## SERVICE BULLETIN

**APPLICABILITY:** 2020-21MY Legacy & Outback  
 2019-21MY Forester  
 2021MY Crosstrek

**NUMBER:** 09-80-21R

**SUBJECT:** DTC # P2682 & P26Ax\*\* / Thermo Control Valve – Design Change

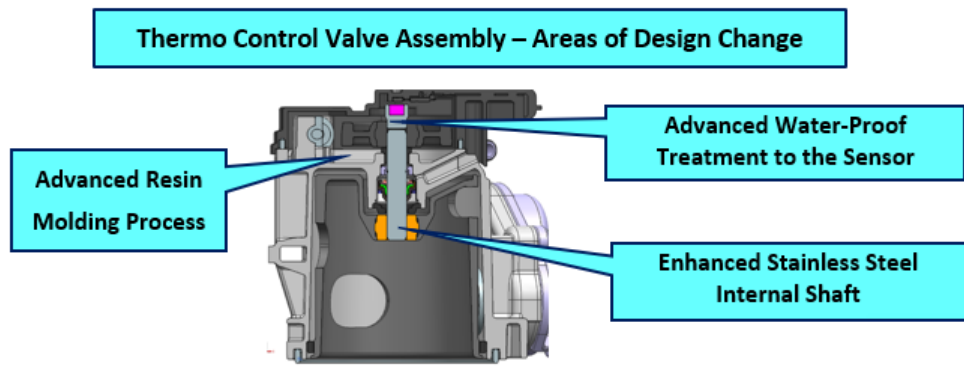
**NOTE:** The new valve assembly comes with a replacement o-ring.

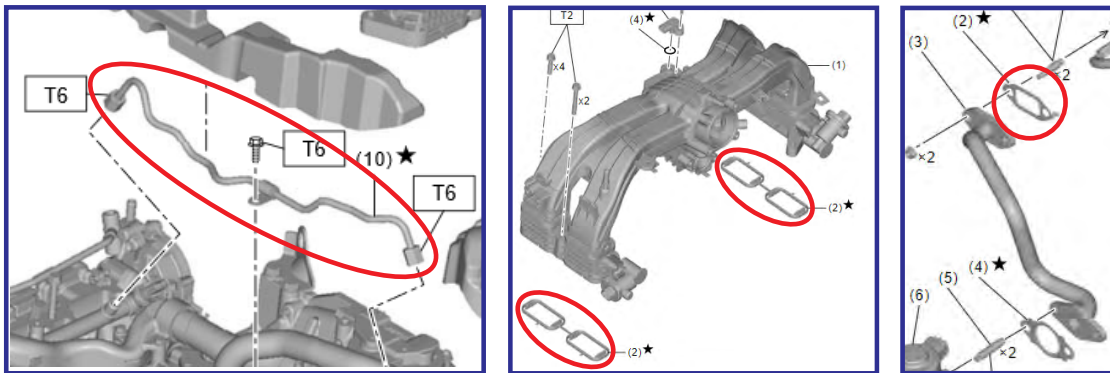
- The Service Manual uses a black star (★) in the component breakdown illustrations to indicate one-time use parts. The high-pressure fuel delivery pipe, intake manifold gaskets, and EGR cooler gaskets are one-time use parts (shown below).
